# Alameda County Fire Department

### Plan Review Comments

<b>To</b>	Miroo Desai, Senior Planner City of Emeryville	<b>PLN #</b>	FDP21-002
<b>Address</b>	CenterCal Properties / 5616 Bay St. Emeryville		
<b>Job Description</b>	Review of Preliminary new market building		
<b>Reviewed By</b>	Cesar Avila, DFM	<b>Date:</b>	9/3/2021
		<b>Review #</b>	1

The Alameda County Fire Department has reviewed the revised proposal dated September 2, 2021 for a new market building.

Alameda County Pumper-Dublin  
 Custom  
 [ft]  
 1" = 10'

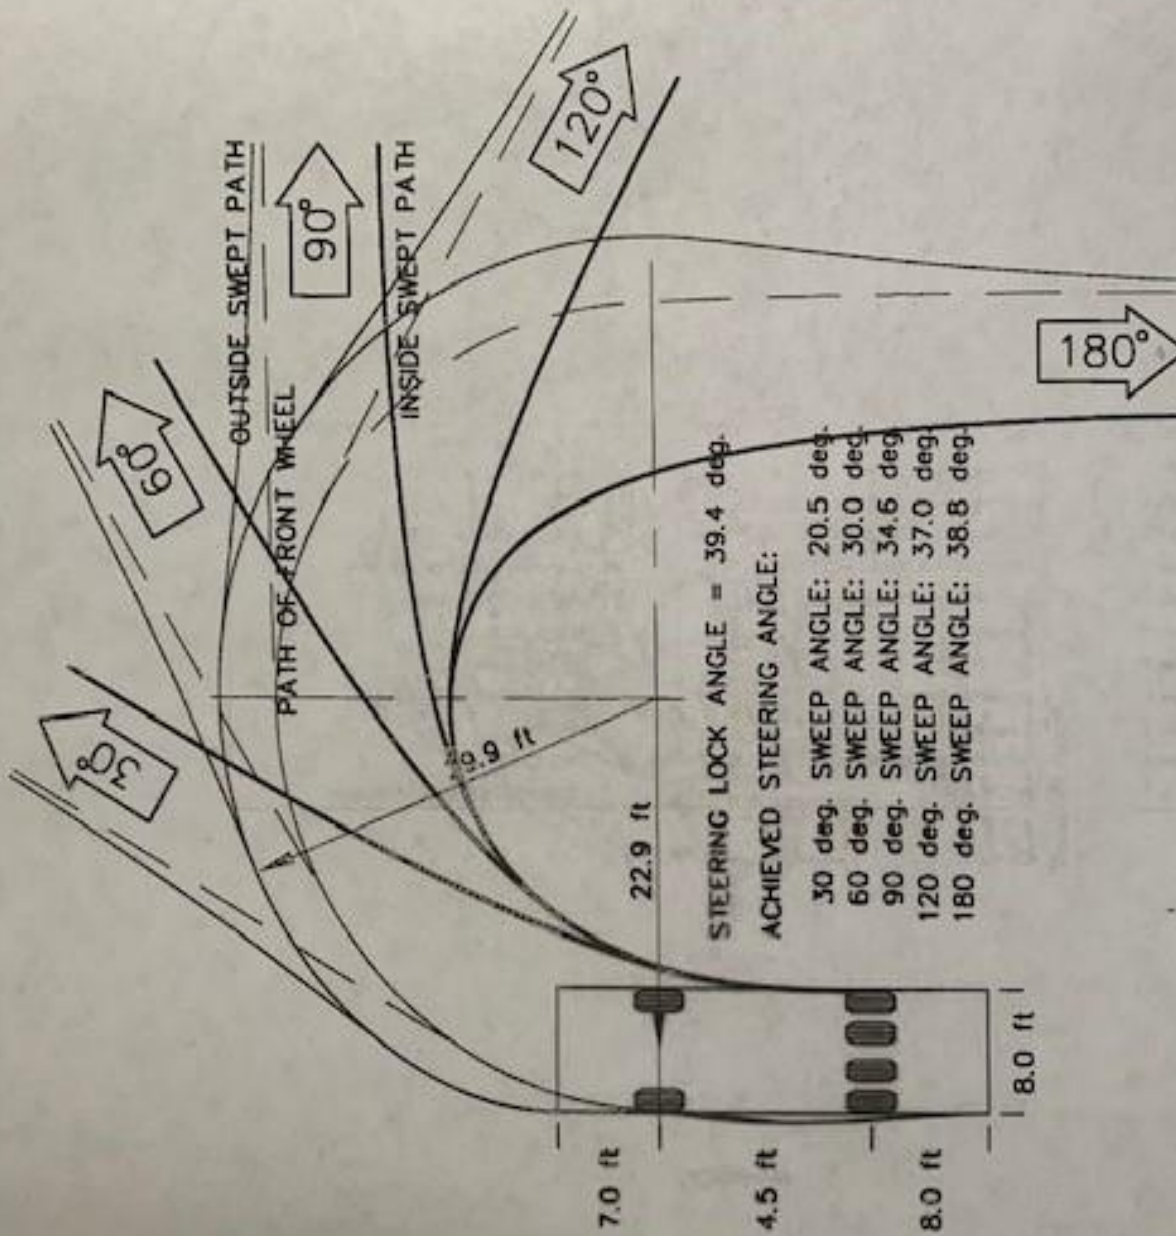
2. Please add a page indicating how the project complies with 2019 California Fire Code Chapter 5 section 503.2.1. Please include a scaled site plan indicating FD apparatus access. Include turning radius (see picture below).
